*Interlocking Arrangements at
Peralam Station.*

Interlocking arrangements
at Peralam station

Report of Inspection of the South Indian Railway System

INSPECTION REPORT FOR THE HALF-YEAR ENDED 30TH JUNE 1898.

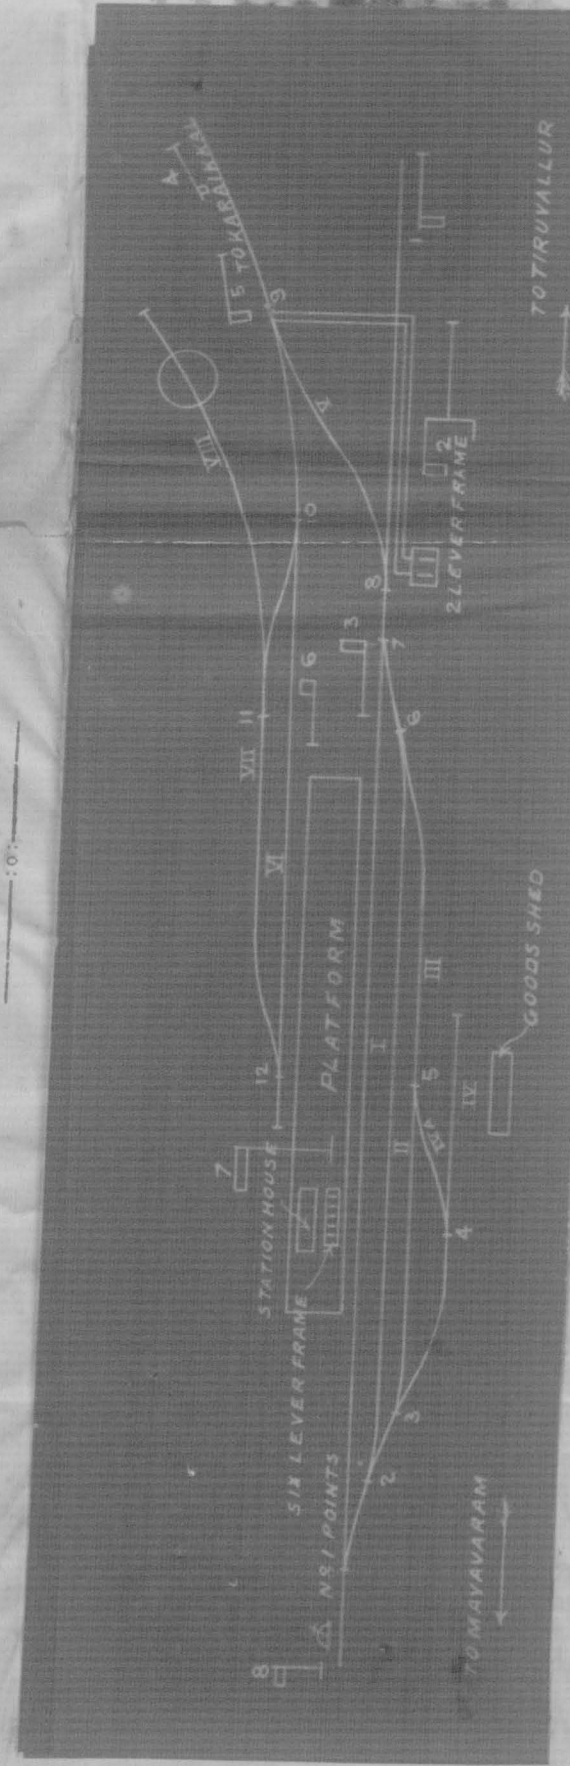
The interlocking arrangements at Peralam were designed and erected by Messrs Sutton and Company. The small ferrotype sketch attached gives the arrangements of the Station, the tracing which also accompanies this letter shows the details of the interlocking arrangements and the Traffic Manager's printed Circular No. 4365 contains the instructions that have been issued for the working of the signals &c, since the arrangements were passed.

The arrangements consist (1st) of a frame containing 6 levers and a locking apparatus erected on the platform, and from which the 6 signals are worked, the frame contains the usual interlocking machinery, (2nd) of the rodding and locking apparatus for the cross over road leading from the Mayavaram Mutpet Railway to the Karaikkal Railway. Both the cross over road points are worked from the points on the Mayavaram Mutpet Railway by 2 levers contained in a frame. The normal position of the crossover road is for the points

points to be set for the Mayavaram Mutupet Railway and in this position they are ^{locked}. When it is required to work the cross-over, the Key has to be taken from the locking apparatus in the 6 lever frame on the platform (and this can only be done when the 6 levers are locked) with this key the lock of the point levers is opened and with one lever the points are released, with the 2^d the points are manipulated. No signal can then be pulled off until the cross over is restored to its normal position the levers locked and the key returned to the frame on the platform.
